STATE OF NORTH CAROLINA DEPARTMENT OF TRANSPORTATION

Addendum No. 1

RE: Contract # C203876 WBS # 38455.3.1 STATE FUNDED **Wake County (B-4655)** Bridge #277 Over Black Creek On SR-1006

3/7/201	7						
3/1/201	·		SHEET NO.				
DOCUMENT NOT C	ONSTDERED	0. BY:	DATE:	NO.	BY:	DATE:	S-2
FINAL UNLES		0		3			TOTAL SHEETS
SIGNATURES CO	OMPLETED 2	2		4			18

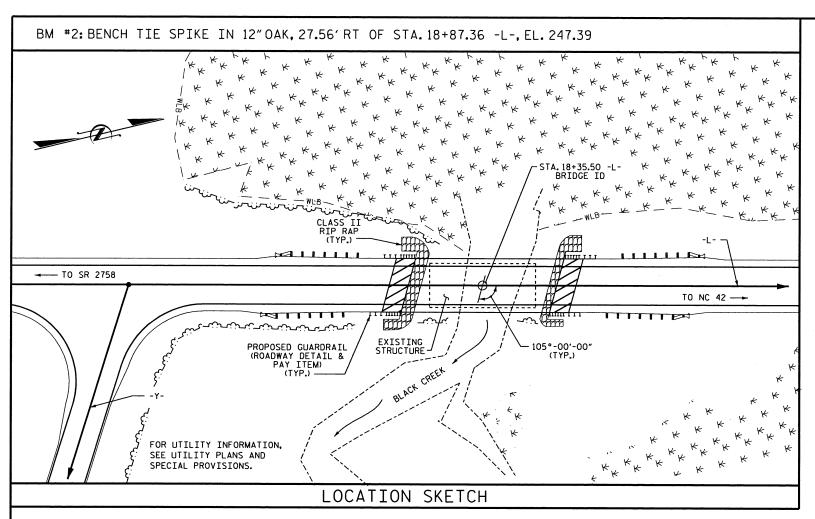
Sheet No.	Revisions							
S-2	Corrected the beam depth for the Prestressed Concrete Box Beams within							
	the "Total Bill Of Material"

Please void sheet No. S-2 in your plans and staple the revised sheet thereto.

TOTAL BILL OF MATERIAL														
	REMOVAL OF EXISTING STRUCTURE	UNCLASSIFIED STRUCTURE EXCAVATION	CLASS A CONCRETE	BRIDGE APPROACH SLABS	REINFORCING STEEL		12 X 53 L PILES	TWO BAR METAL RAIL	1'-2"X 2'-9½" CONCRETE PARAPET	RIP RAP CLASS II (2'-0"THICK)	GEOTEXTILE FOR DRAINAGE	ELASTOMERIC BEARINGS	PRES CO	"X 2'-9" STRESSED NCRETE (BEAMS	ASBESTOS ASSESSMENT
	LUMP SUM	LUMP SUM	CU. YDS.	LUMP SUM	LBS.	NO.	LIN.FT.	LIN.FT.	LIN.FT.	TON	SQ. YD.	LUMP SUM	NO.	LIN. FT.	LUMP SUM
SUPERSTRUCTURE								154.37	170.00			LUMP SUM	11	935.0	LUMP SUM
END BENT 1			18.8		3110	7	210			85	95				
END BENT 2			18.8		3110	7	125			55	60			ļ	
TOTAL	LUMP SUM	LUMP SUM	37.6	LUMP SUM	6220	14	335	154.37	170.00	90	155	LUMP SUM	11	935.0	LUMP SUM
